Date: 03-17-25

Project Number: 56-3016-25

Project Name: HPWO - New Carlisle Phase 1 Selective Demolition - Community Health Center

Intent:

DRAWN BY: SAB
 DATE: 11-24
 PLOT SCALE: 1:1
 JOB NO. 56-3016-24
 SHEET DM103

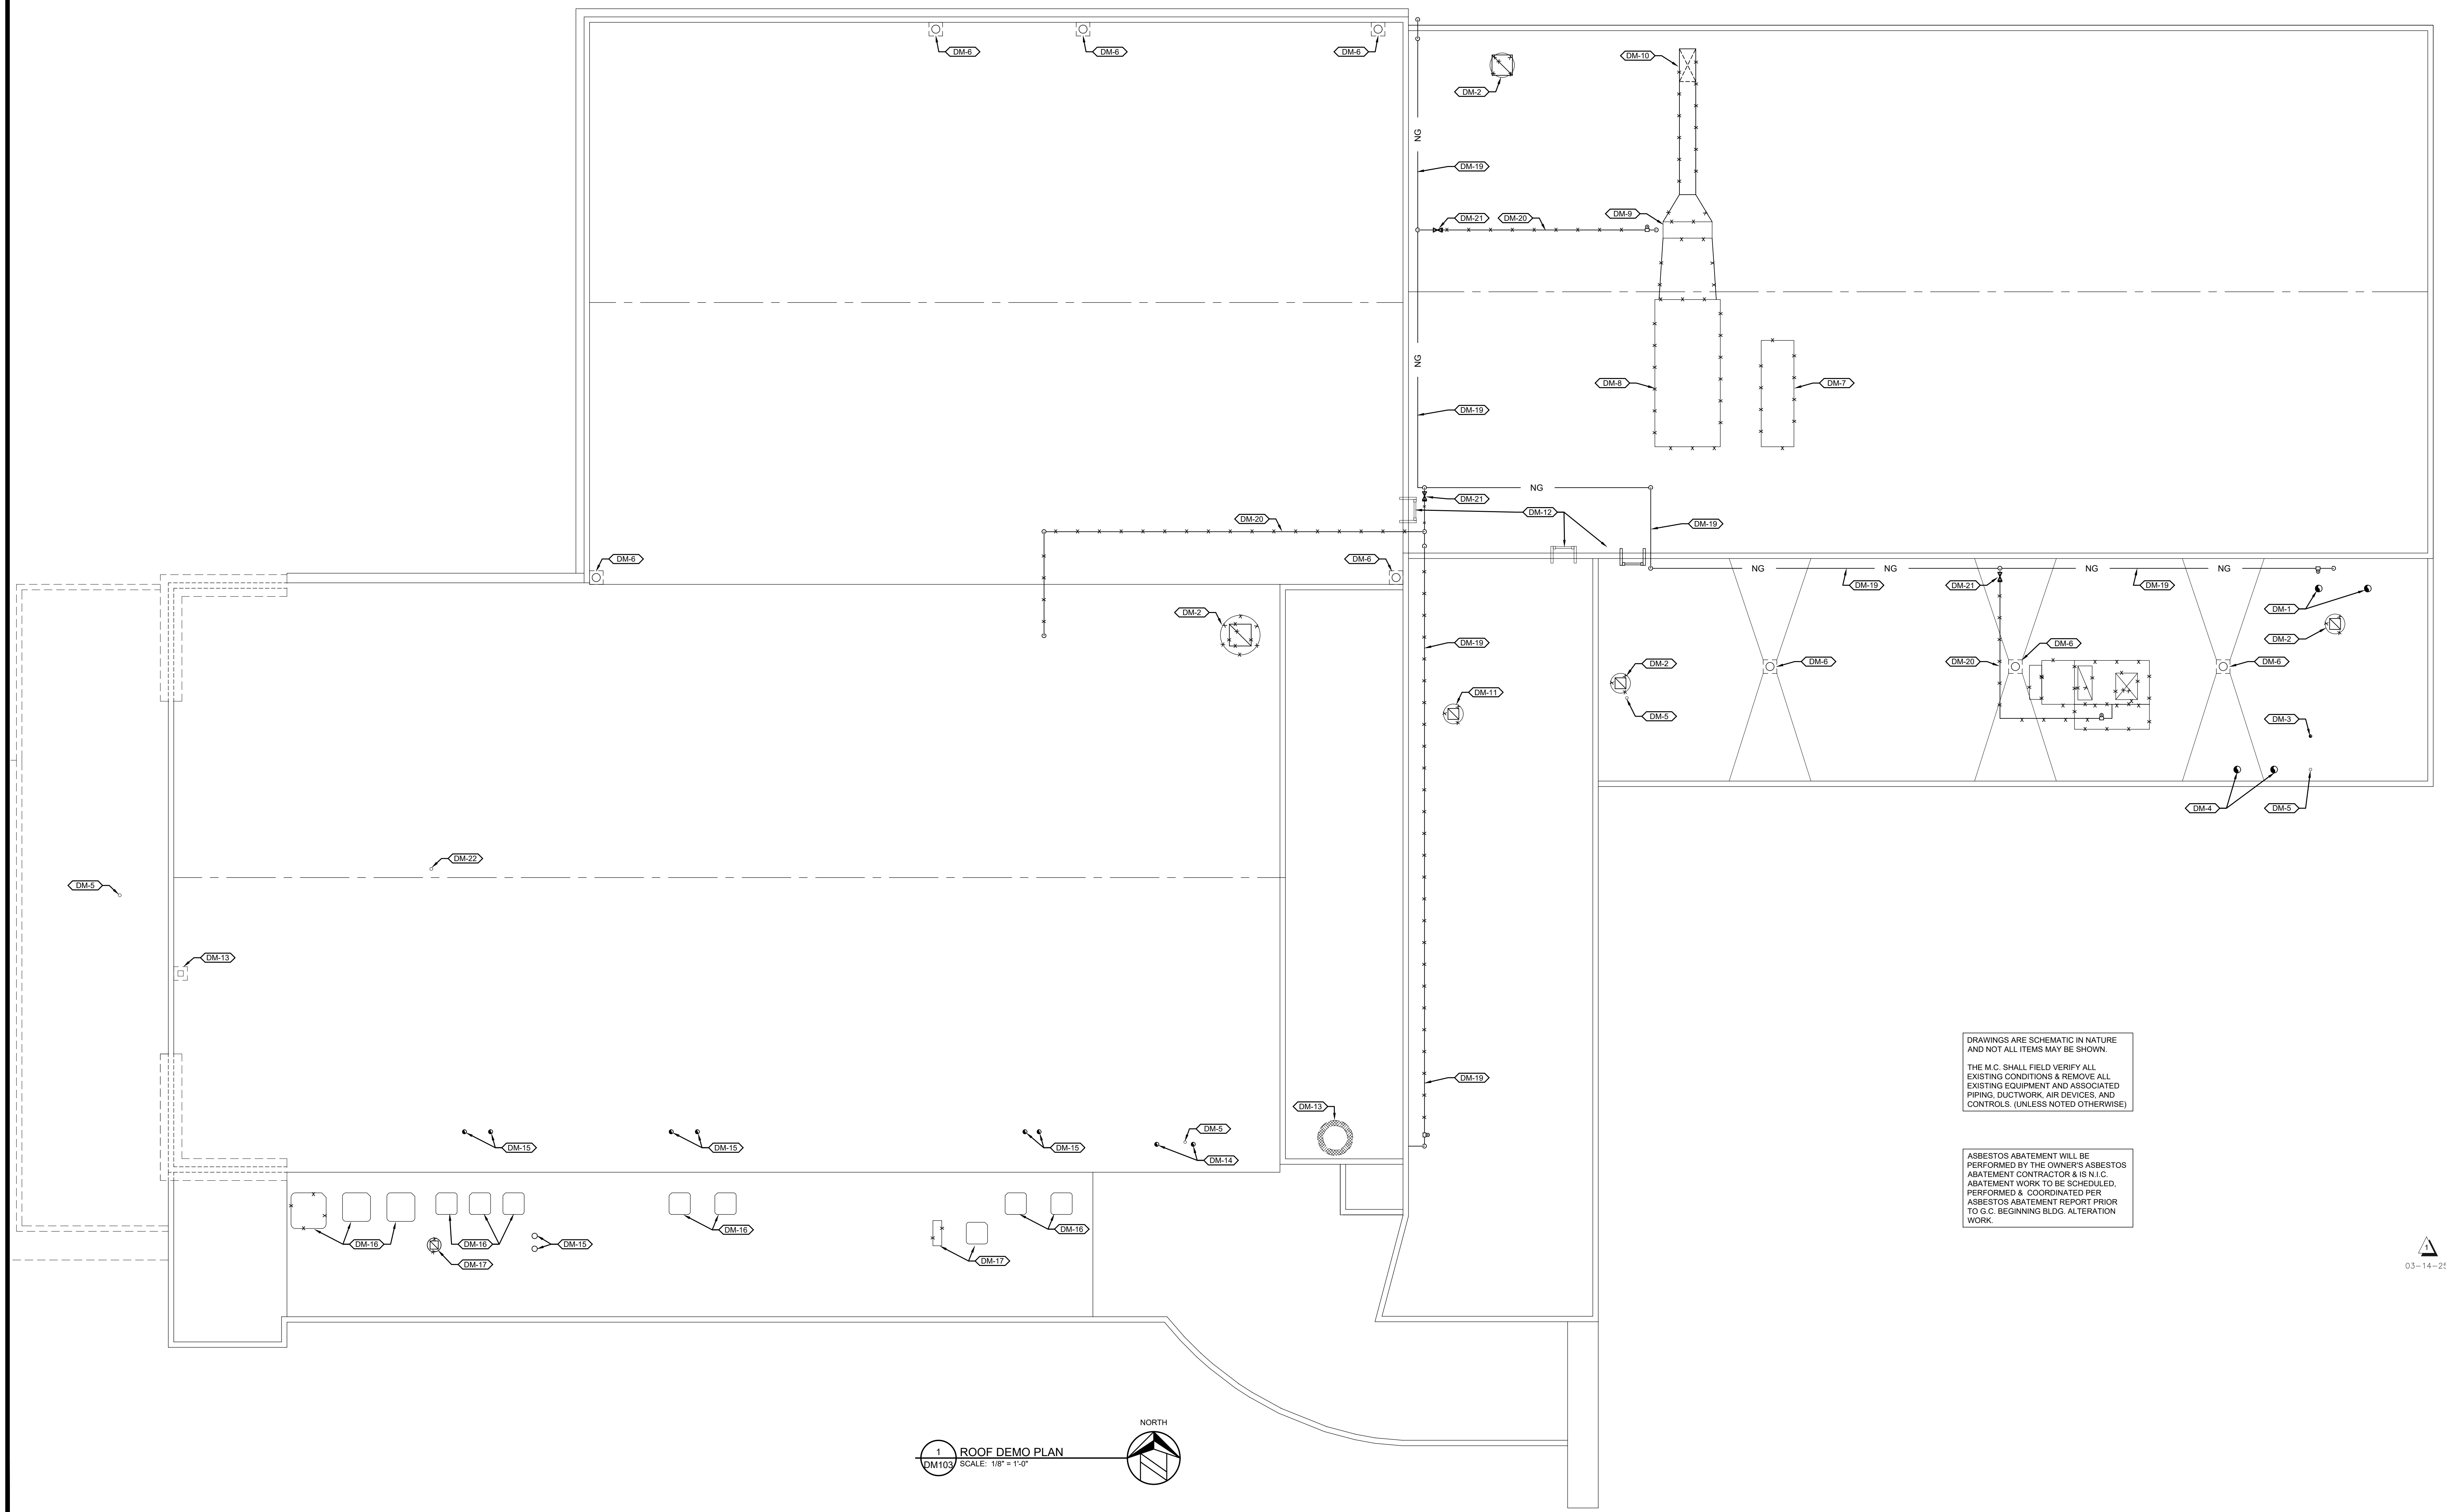
Item	Additional Document	Cons. Doc. Reference	Description
General:			
1	Pre-bid Mtg. Minutes		See attached
Architectural:			
2		D101	Keynotes CC & DD added, existing shelving to be salvaged. Owner to retain
3		D102	Keynotes CC & DD added, existing shelving to be salvaged. Owner to retain
Mechanical / Plumbing:			
4		DP103	Keynote 15 edited, existing chimney to remain
5		DM103	Keynote 15 edited, existing chimney to remain
End of Addendum 01

- EXISTING ROOF ACCESS LADDER TO REMAIN.
- EXISTING CHIMNEY TO REMAIN.
- EXISTING EXHAUST GOOSENECKS THRU ROOF TO BE REMOVED. PATCH ROOF AS REQUIRED.
- EXISTING FURNACE FLUES THRU ROOF TO BE REMOVED. PATCH ROOF AS REQUIRED.
